**DEL WEBB AT MIREHAVEN PHASE 3 & 4  
 (TRACT M AND TRACT N-2-A-1, WATERSHED)**

Re: Del Webb at Mirehaven Phase 3&4 Grading and Drainage Plan and Drainage Report  
Engineers Stamp Dated: 05/10/2018 (H09D017G)

Enclosed are responses to the comments provided on June 19, 2018. Responses are listed in red below.

CITY PROJECT NO. \_\_\_\_\_ ZONE MAP NO. **H-8/9** SHEET **4** OF **6**

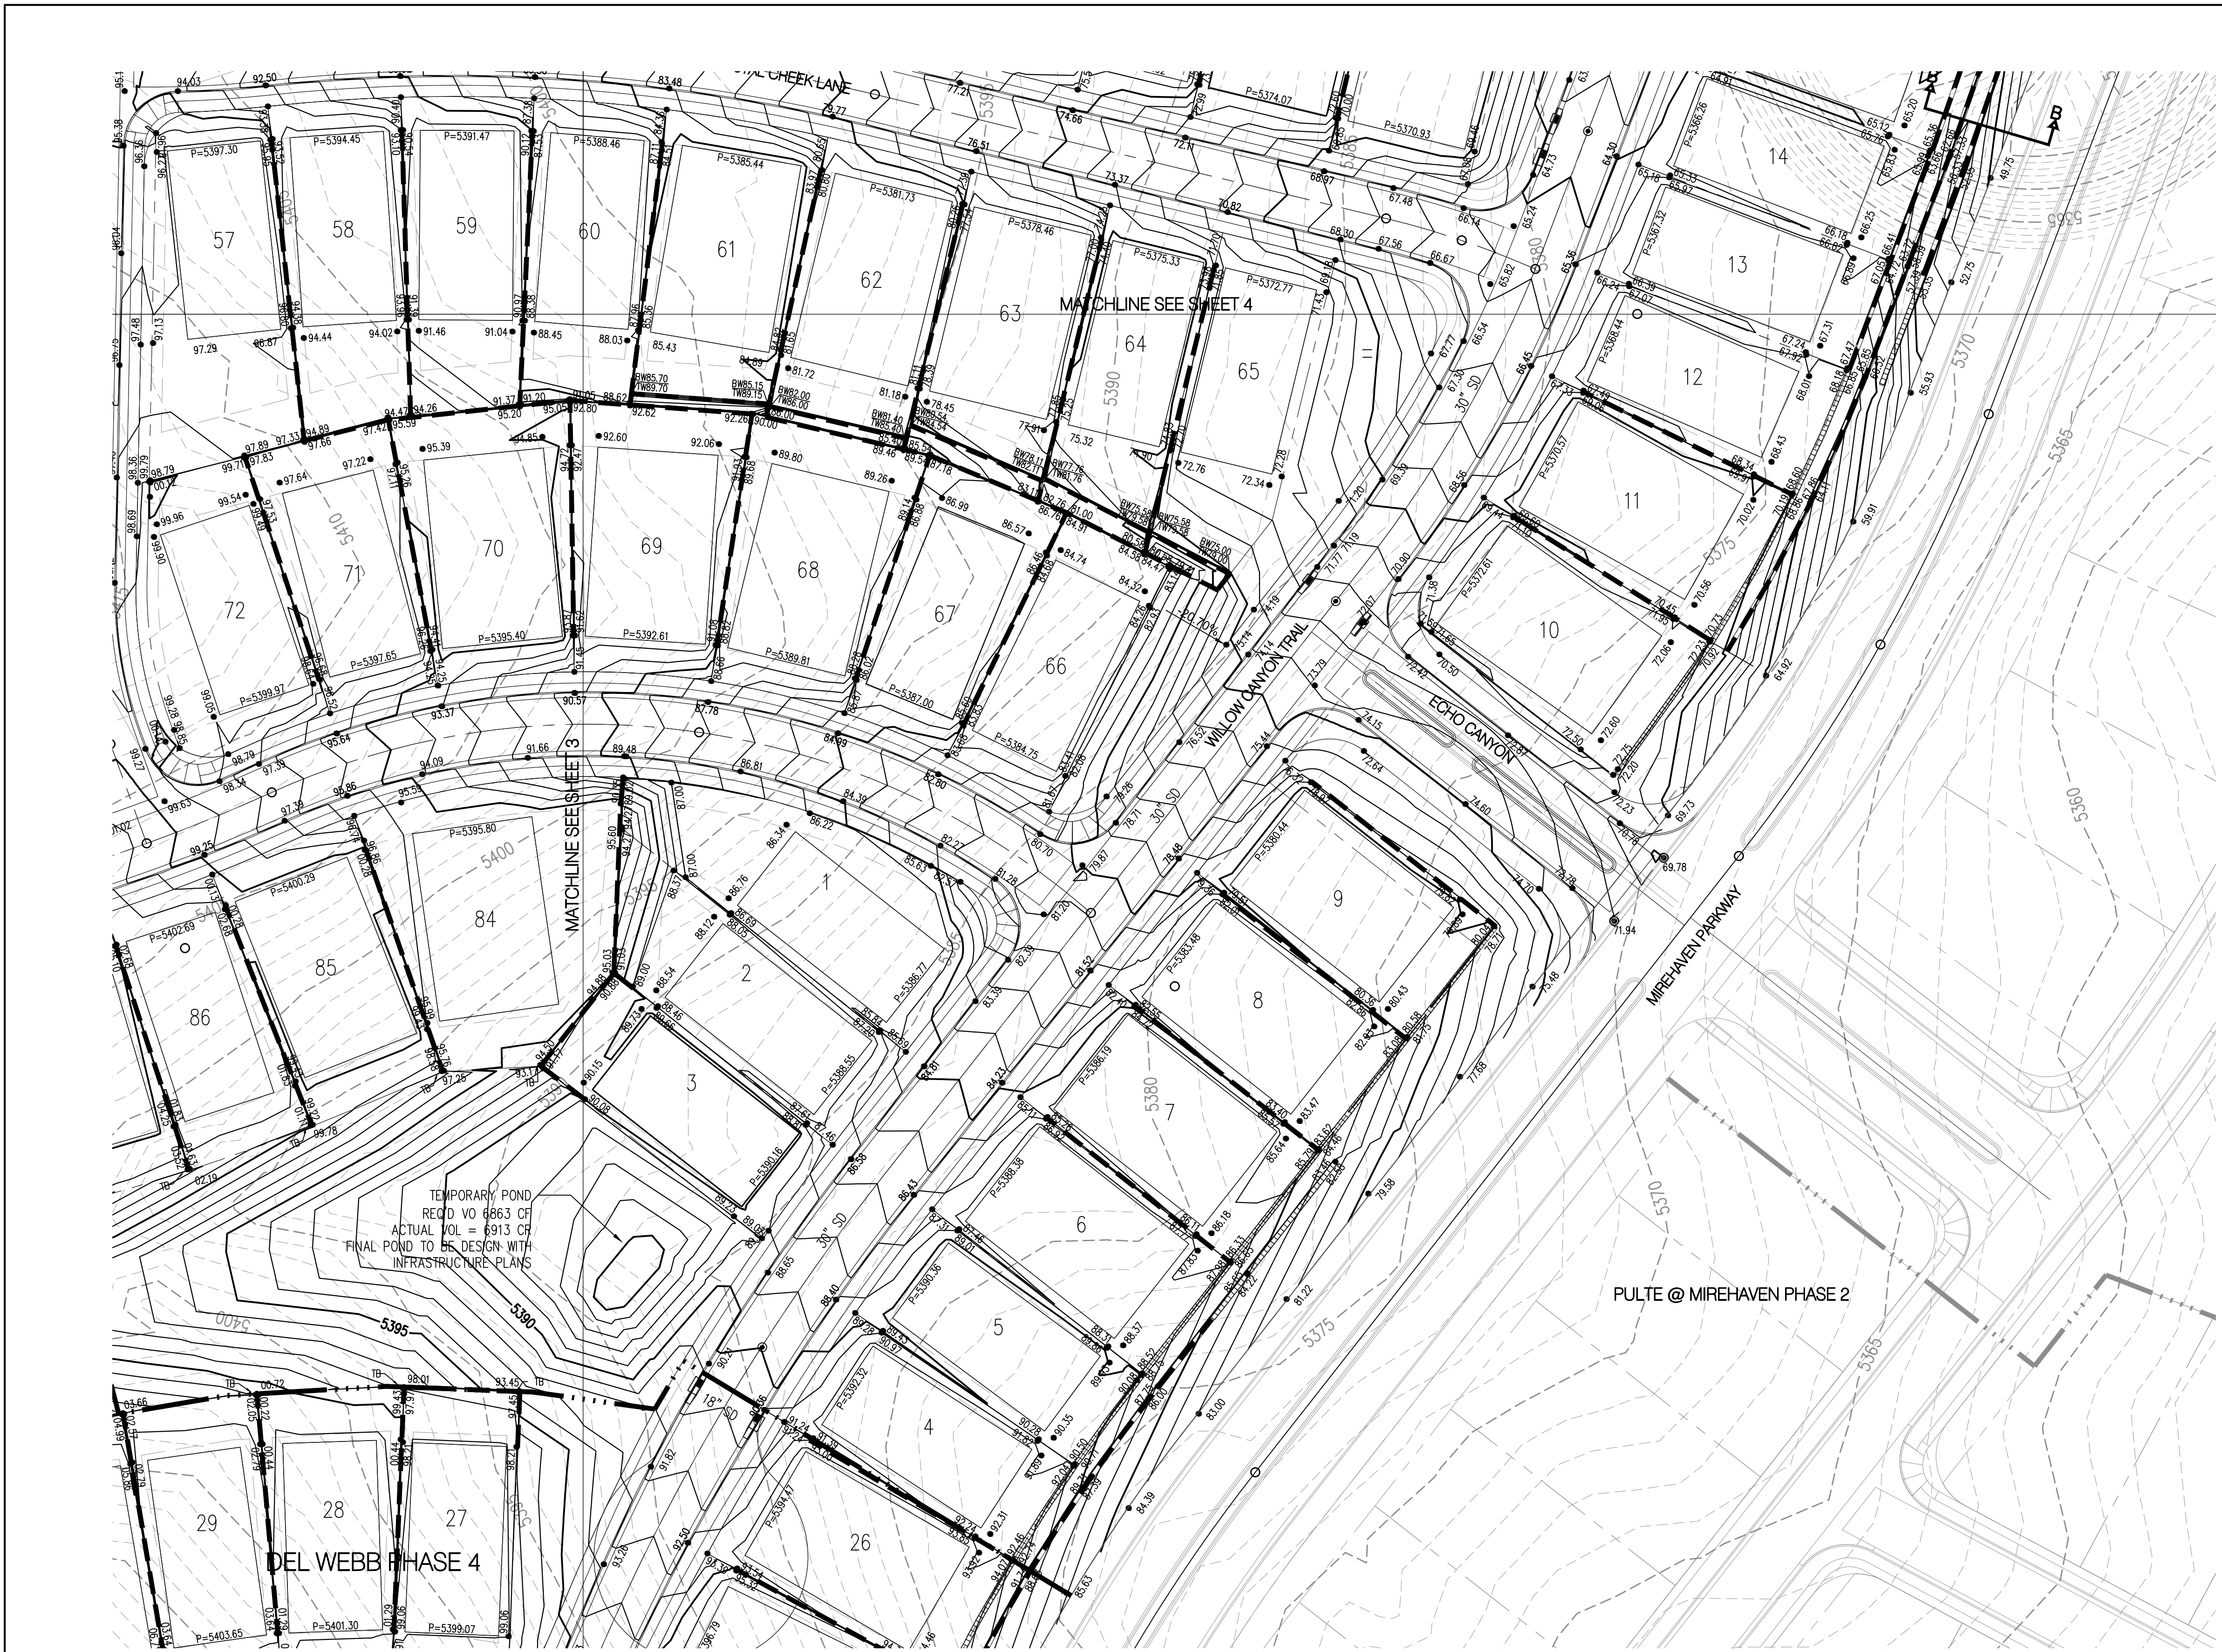
1. Show the Property line in the wall sections, and include dimensions. The PL is still missing in the Unit 3 Plan Sheet 4 Section BB which also shows a 4:1 in the right of way where a trail should be shown. The plan view at this location shows an excessively steep, 2:1, slope. Additional wall(s) is required. Please correct both the plan view and the section. **Cross-sections have been updated. There was a mistake in the elevations which have been corrected and the contours and elevations represent the correct 4:1 slope.**
